Morris Goding
Access Consulting

RE: Access Design Statement – accessible parking unmarked shared area

Diagram 1

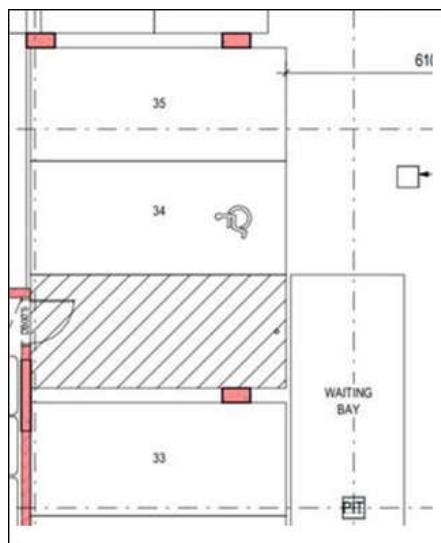
I hereby state that the proposed relocation of the unmarked shared area (diagram 1); that is adjacent to the accessible dedicated space is in accordance with AS/NZS 2890.6:2009 – Parking facilities – Part 6: Off street parking for people with disabilities (diagram 2):
